Design Review Board Case # 20-0002
Block 32 – Carlyle Plaza II / Carlyle Park Towers

Block 32 – DRB Open Space Review

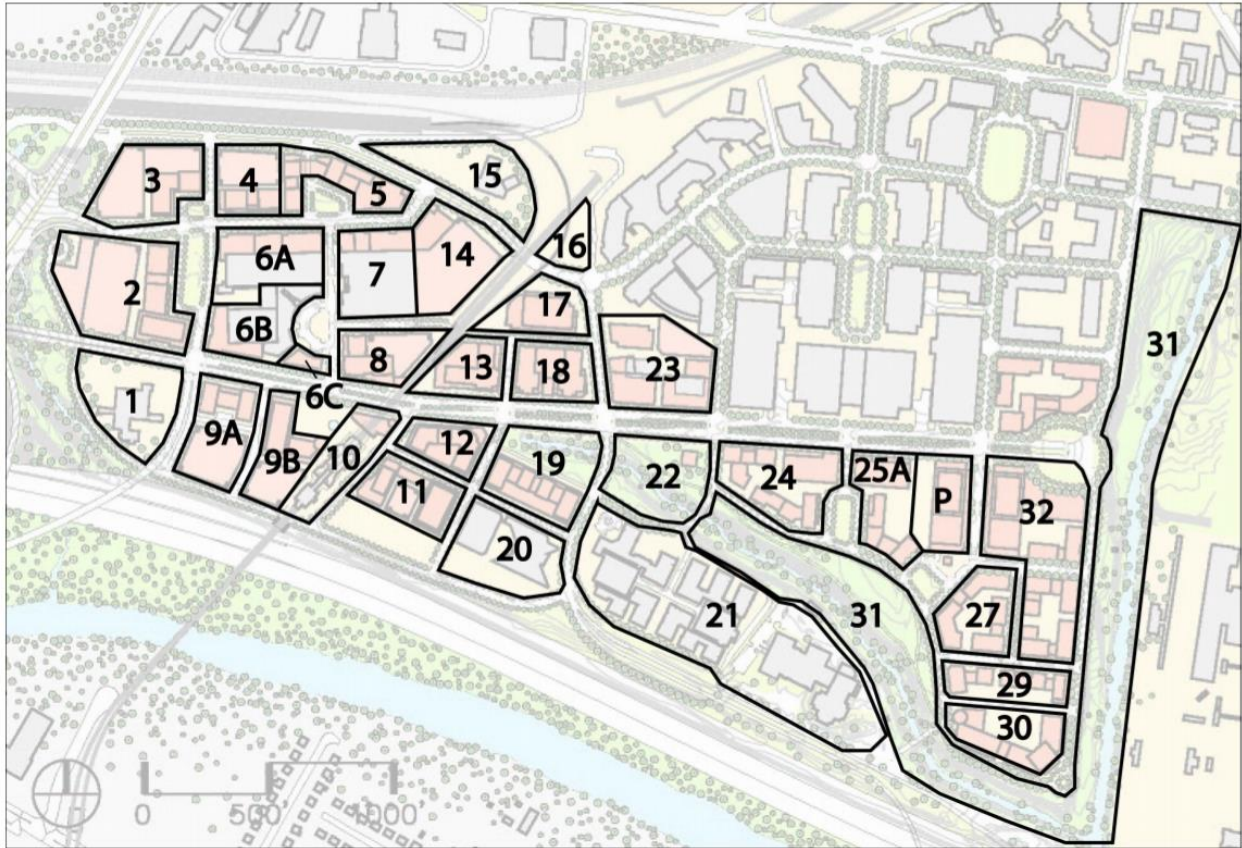
The applicant has proposed several significant changes to the overall approved open space design for the Block 32 development, most significant being (1) the removal of the elevated bike ramp that extended from the top of the elevated deck to an at-grade location near the location of Eisenhower Avenue, (2) the removal of a continuous slope on the open space deck, (3) the redesign of the transition zone, (4) the redesign of the North and South Circle parks, and (5) the addition of a large private open space area between Tower 1 and Tower 2. These changes are illustrated in Attachment #4 "Notable Block 32 Open Space Changes".

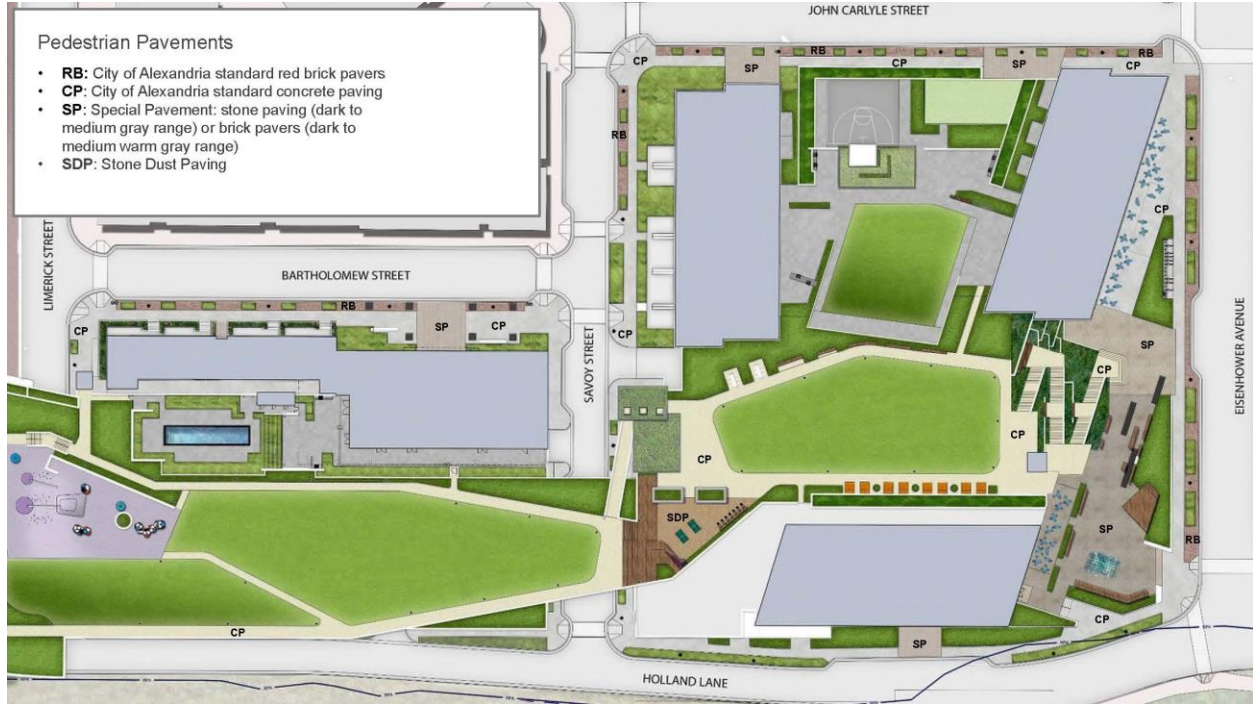
1. All elevators with access to the elevated open space deck should be called out in a similar manner with color or extensive use of glass, or both, to make them more identifiable to pedestrian and more inviting to visit the elevated park.
